TECHNICAL BULLETIN

BULLETIN #: SP8211-2507	**NOTICE:**
DATE: 07/25/2025	**THIS DOCUMENT CONTAINS INFORMATION PROPRIETARY TO ACCUTEMP PRODUCTS, INC. AND IS TO BE USED ONLY BY AUTHORIZED SERVICE PERSONNEL. DUPLICATION OR REPRODUCTION OF THIS DOCUMENT IN ANY OTHER FORM, IN WHOLE OR IN PART, IS STRICTLY PROHIBITED**
SUBJECT: Evolution Steamer Quantum to API board swap	
MODELS: ALL	
SERIAL NUMBER: ALL

Part Number: AT1E-6887-1-R0X

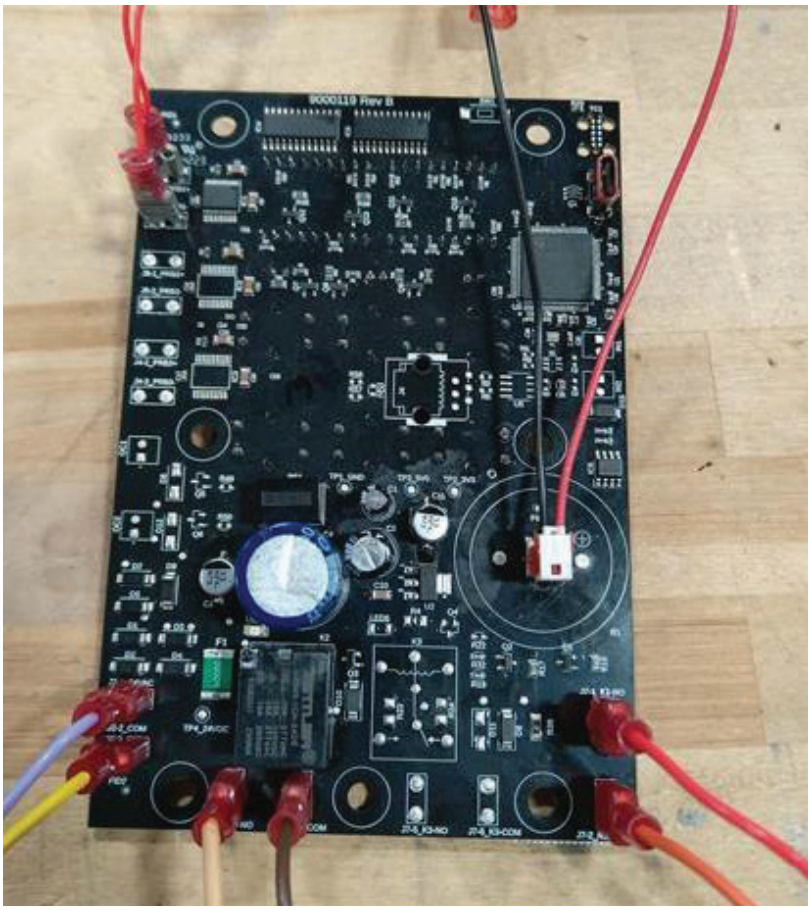
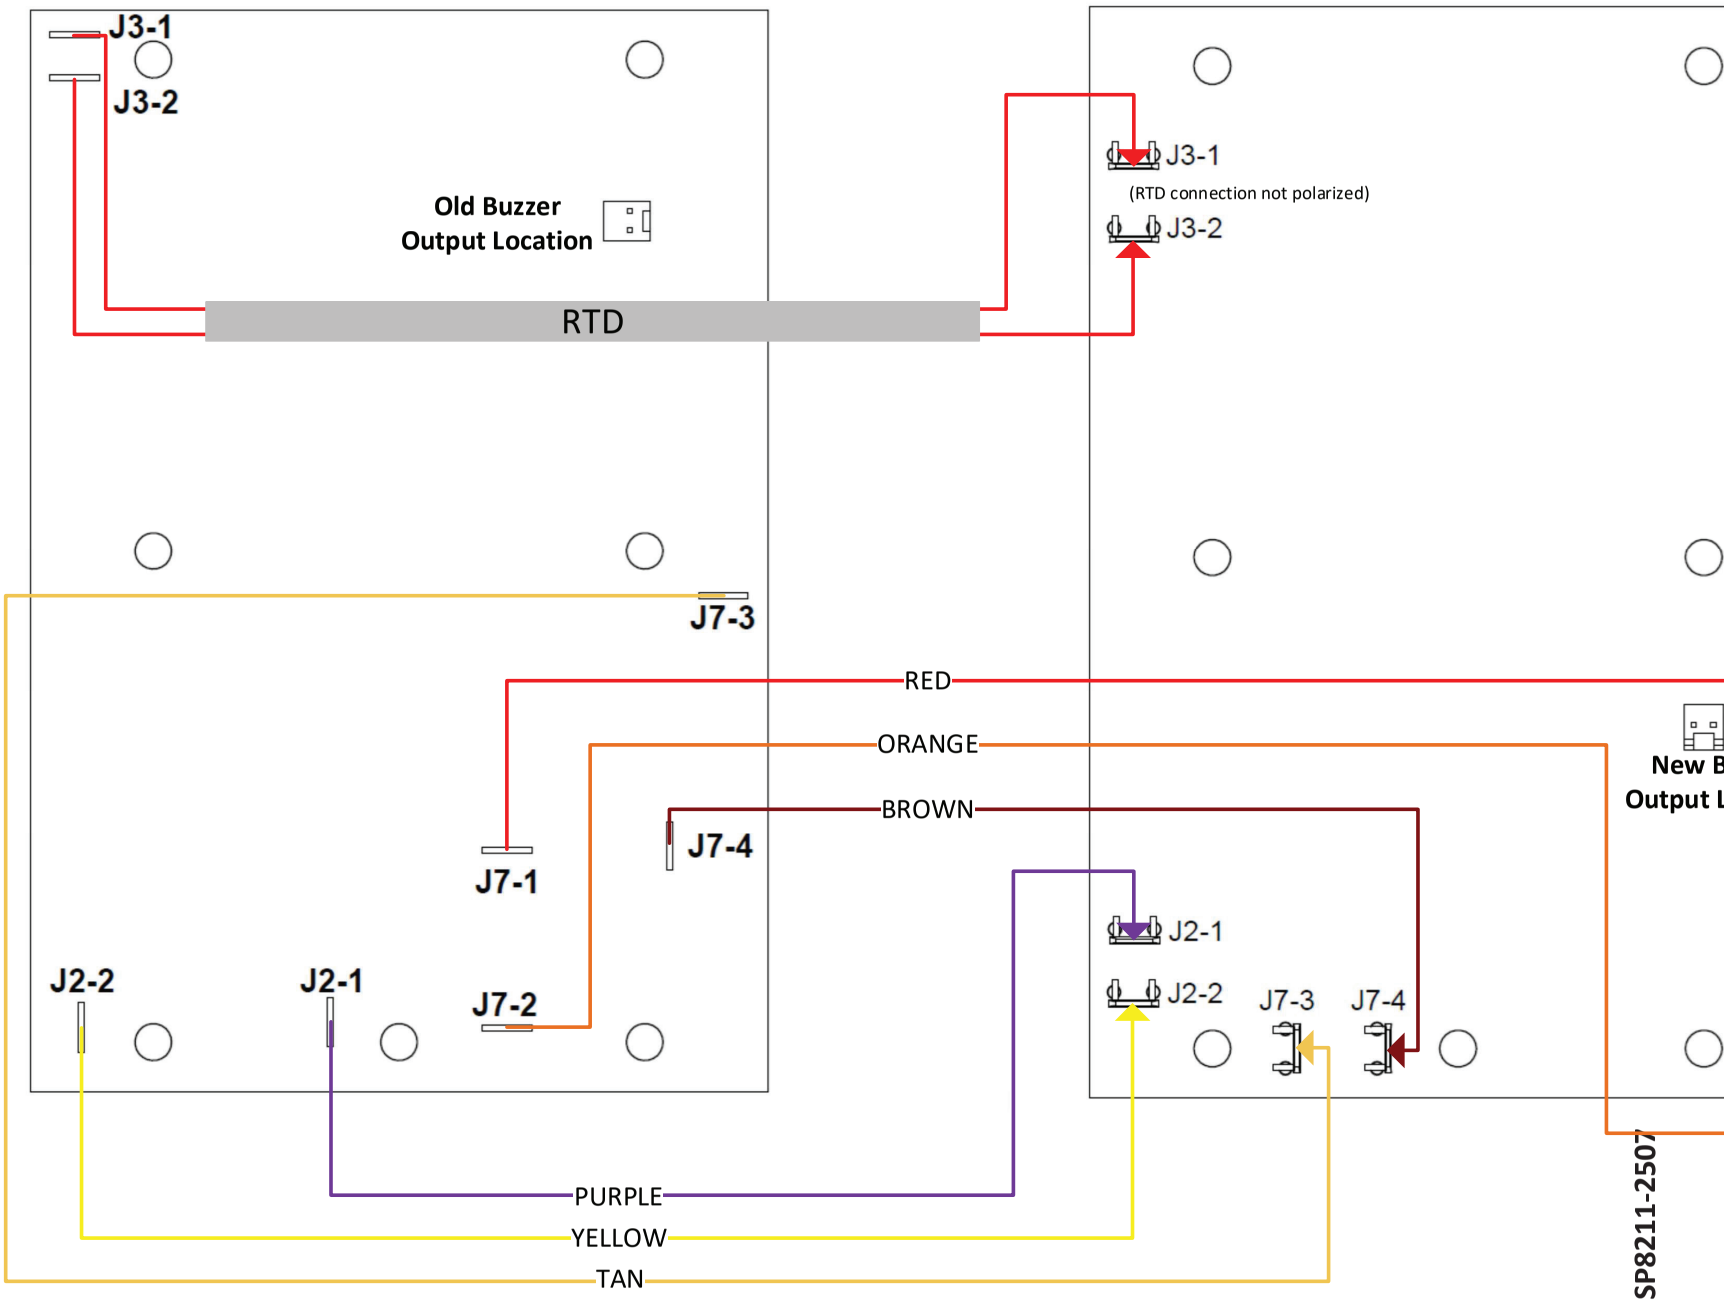
Converti ng the Quantum Digital Controller to the new API Digital Controller is a simple wire for wire part swap, but does require some additi onal att enti on to detail to ensure the replacement is done properly. Please note the pin labels remain the same, but the physical locati on of the pin layout on the board changes. Use the below diagram to identi fy the wire color and new locati on on the new board.

J3-1
J3-2
Old Buzzer
Output Location
RTD
J3-1
(RTD connection not polarized)
J3-2
J7-3
RED
ORANGE
BROWN
J7-4
J7-1
J2-1
J2-2
J7-2
J2-1
J2-2
J7-3
J7-4
PURPLE
YELLOW
TAN
New B
Output L
